Additional Information Response  
**DUB11 CAMPUS DEVELOPMENT**  
Design Statement in support of  
Planning Application

DUB11-DC-XX-G021-V1-PL-BMD

Revised Feb 28<sup>th</sup>, 2022

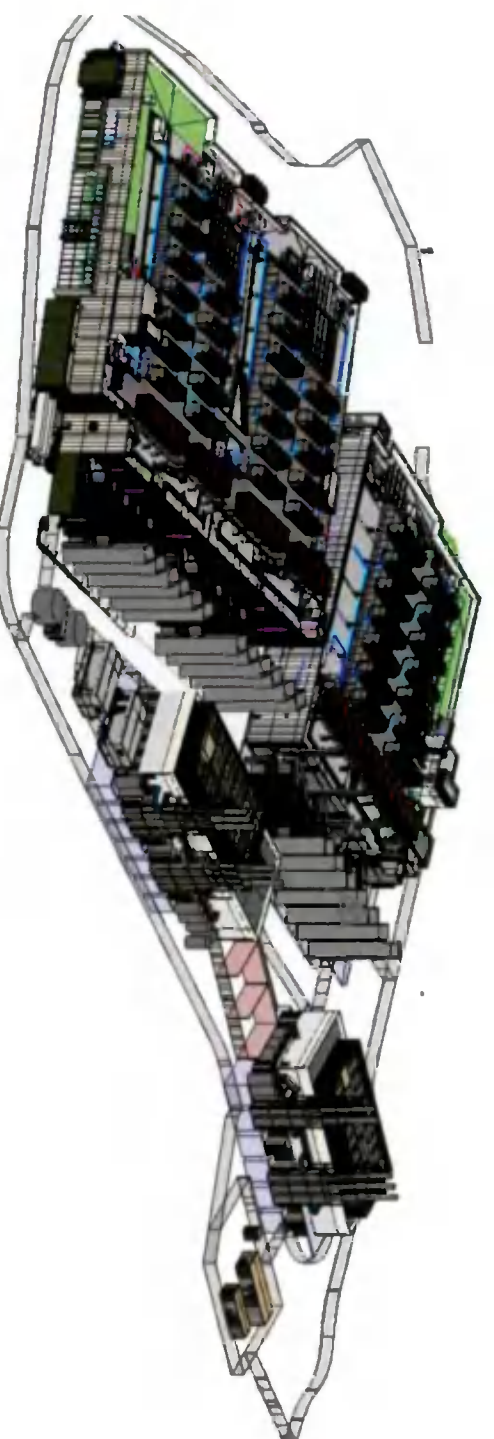
(e) It is noted that there are a number of inconsistencies between the description of development and the submitted plans and elevations:

- (i) The permanent power plant, according to submitted plans provides the following: Height – Ridge 11.55m and eaves 9.5m, chiller deck at 12.5m. It is noted that the description of development sets out that this building is 13m high.
- (ii) The temporary power plant, according to the submitted plans, provides the following: Flue height 14.4m. It is noted that the description of development sets out that the flue are 25m high.

The design team have explored ways to reduce the height of the Power Plant building. In parallel the Engineering team have worked with the key engine supplier to refine the engineering design to achieve best in class performance in terms of emissions, noise and sustainability. The outcome for the building envelope is an increase in height of the radiator screen from 14.5 to 18metres, the building parapet from 12.5 to 13.90 and the chiller deck from 12.50 to 15.40 metres. The roof design is changed to a flat slab in place of the pitched roof on the original application. This allows the building to house the scrubbers, silencers and attenuators required to achieve the required environmental performance. To meet the emissions monitoring standard, the flue height is increased to 30 metres.
